# SITE PLAN & ARCHITECTURAL COMMISSION AGENDA AUGUST 17, 2018

PROJECT Lock & Key Vilas Road  
Applicant: RKKP, LLC dba Lock & Key  
Agent: John Duffie, Straus & Seibert Architects

FILE NO. AC-18-061

for a Type-C quasi-judicial decision: **SITE PLAN & ARCHITECTURAL REVIEW**

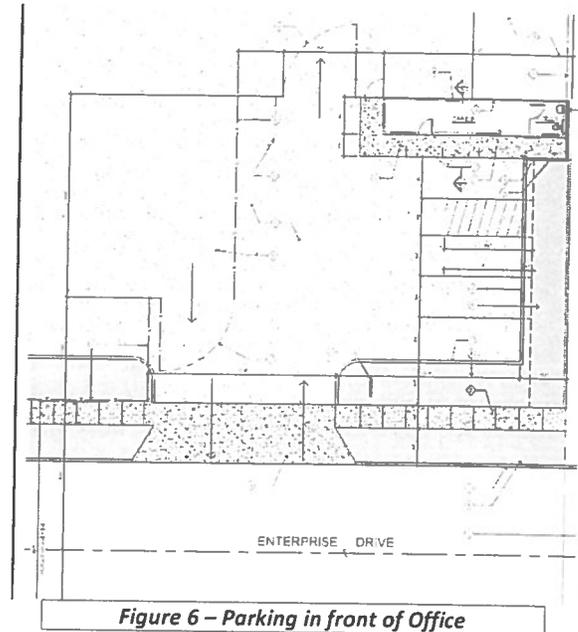
It is staff’s opinion that the proposed amount of marked vehicle parking spaces adjacent to the office and the amount of unmarked parking spaces within the drive aisles is adequate and the parking requirement is therefore met.

**Decision:** There was discussion during the public hearing regarding the amount of marked parking stalls and handicap accessible parking stalls. Ultimately, the Commission decided to grant relief to the amount of marked vehicle parking spaces as shown on the site plan and that the applicant shall provide adequate parking as required by ADA standards. In addition, the Commission granted relief on Section 10.746(3) – Parking Area Planters.

Figure 9 – Proposed Street Frontage Landscaping along E Vilas Road

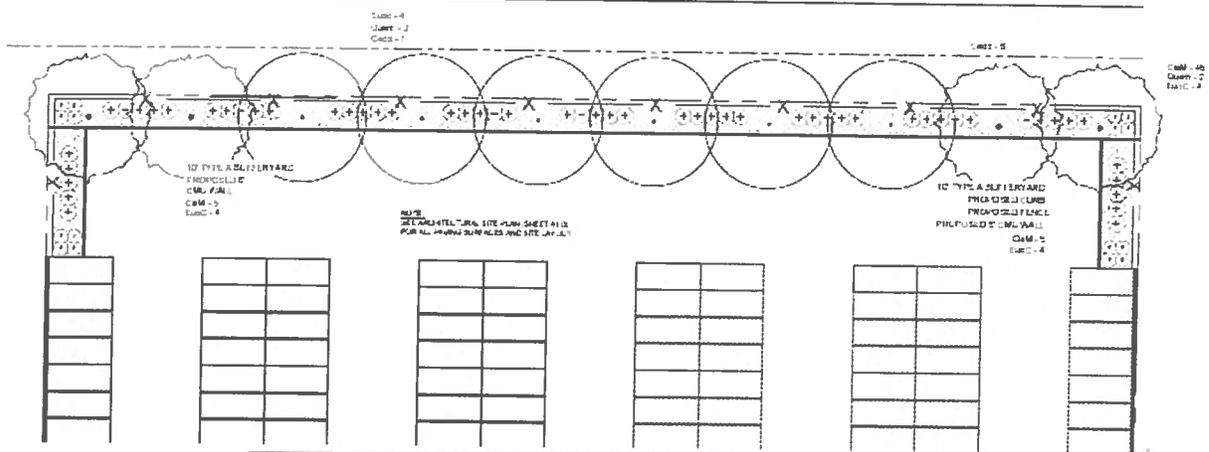
However, the submitted landscape plan lacks one street tree along Vilas Road and the trees along Enterprise Drive are partially shown to be placed within the public right-of-way (see figure 10, below). MLDC 10.797 requires that all street frontage landscaping be placed outside the public right-of-way.

It will be a condition of approval for the applicant to meet all applicable requirements of MLDC 10.797. However, even though not expressly requested by the applicant, staff is in favor of the Commission accepting the street tree placement along Enterprise Drive, as submitted. The partial placement of required street frontage trees within the public right-of-way would match existing conditions in the neighborhood as can be seen in Figure 11, below.

**Decision:** The Commission’s approval included that some street trees can be planted in the Enterprise Drive right-of-way.

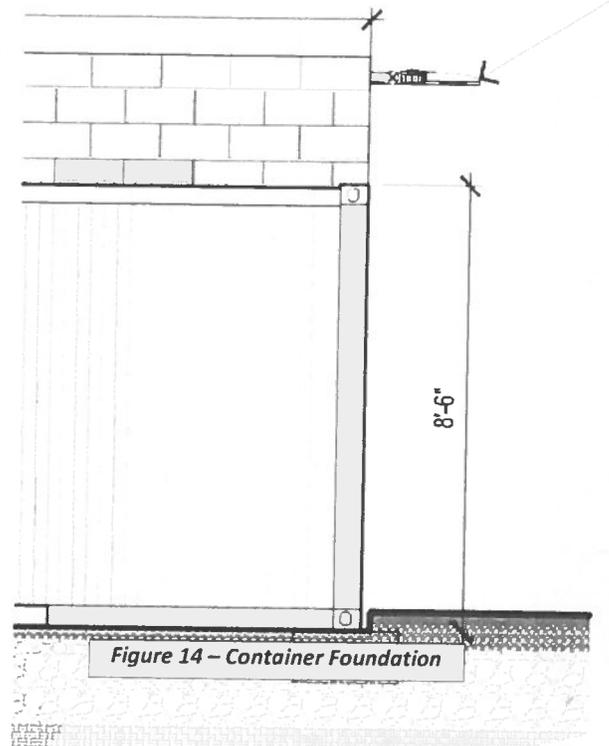
MLDC 10.746 states, in part, *with the exception of storage of trailered items and recreational vehicles at single-family residences, all parking, loading, driveway, and vehicle maneuvering areas, including but not limited to, wheeled-vehicle sales lots, truck trailer parking areas, and on-site single-family residential driveways etc., shall be paved and improved pursuant to the following design requirements (...).*

An Exception to the paving standard in MLDC 10.746 is required for the proposed use of gravel. At the time of this writing, an Exception application has not been submitted. As the applicant is seeking timely approval for the main development, staff has included a condition of approval requiring paving per MLDC 10.746. If the applicant decides not to pave, they may install curbing per the Public Works Department report or apply for an Exception for relief from the standard.

3. Submit a revised Site Plan showing the pavement of all vehicle parking and maneuvering areas – including the proposed RV and boat storage areas – per MLDC 10.746.
4. Submit a revised Landscape Plan complying with all applicable requirements per MLDC 10.797 – Street Frontage Landscaping.
5. Submit revised Site Plan showing bufferyards complying with all applicable requirements per MLDC 10.790 in applicable areas that are not developed with shipping containers.
6. Comply with all conditions stipulated by the Public Works Department (Exhibit P).
7. Comply with all conditions stipulated by the Fire Department (Exhibit R).
8. Comply with all conditions stipulated by the Medford Water Commission (Exhibit Q).
9. Contact the Federal Aviation Administration regarding the filing of a 7460-1 Notice of Proposed Construction and Alteration form (Exhibit W).
